Access Compliance Report

Public Rights-of-Way

(Curb Ramps)

Intersection ID: 50615	Main Street: FAWN_LILY	Cross Street: BALSAM_BAY_RD	Location: SW
ADA ID: 2EC439CE8B1F	Ramp Type: Perp	Initial Pass/Fail: Fail	Overall Compliance: No
		Severity Score: 12.5

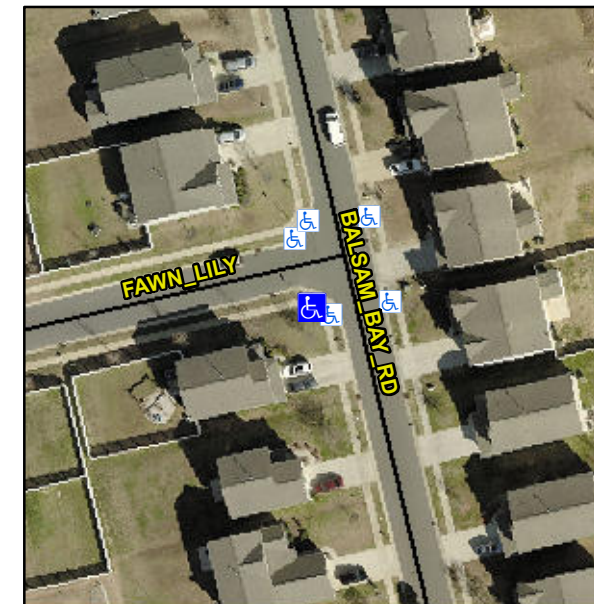
Not Found, R304.2.2

Compliance	Description	Data	Compliance	Description	Data
N/A	Ramp Length (in)	48.0	No	Ramp Slope (%)	11.4
Yes	Ramp Width (in)	48.0	Yes	Ramp XSlope (%)	1.4
N/A	Flare Type LT	N/A	N/A	Flare Type RT	N/A
N/A	Flare Slope LT (%)	N/A	N/A	Flare Slope RT (%)	N/A
N/A	Flare Traversable LT?	N/A	N/A	Flare Traversable RT?	N/A
N/A	Landing Length (in)	N/A	N/A	DWS Provided?	N/A
N/A	Landing Width (in)	N/A	N/A	DWS Contrast?	N/A
N/A	Landing Slope (%)	N/A	N/A	DWS Length (in)	N/A
N/A	Landing X Slope (%)	N/A	N/A	DWS Full Width?	N/A
N/A	Landing Curb? (Y/N)	N/A	N/A	DWS Offset (in)	N/A
N/A	Shared Landing?	N/A			
N/A	Gutter Ponding?	N/A	N/A	Gutter Slope (%)	N/A
N/A	Gutter Lip Ht (in)	N/A	N/A	Gutter X Slope (%)	N/A
N/A	Painted X Walk1?	No	N/A	Painted X Walk2?	N/A
	X Walk 1 Direction	To N		X Walk 2 Direction	N/A
N/A	X Walk 1 Width (in)	N/A	N/A	X Walk 2 Width (in)	N/A
	X Walk 1 Slope (%)	0.9		X Walk 2 Slope (%)	N/A
	X Walk 1 X Slope (%)	0.2		X Walk 2 X Slope (%)	N/A

Remove & Replace Entire Ramp.
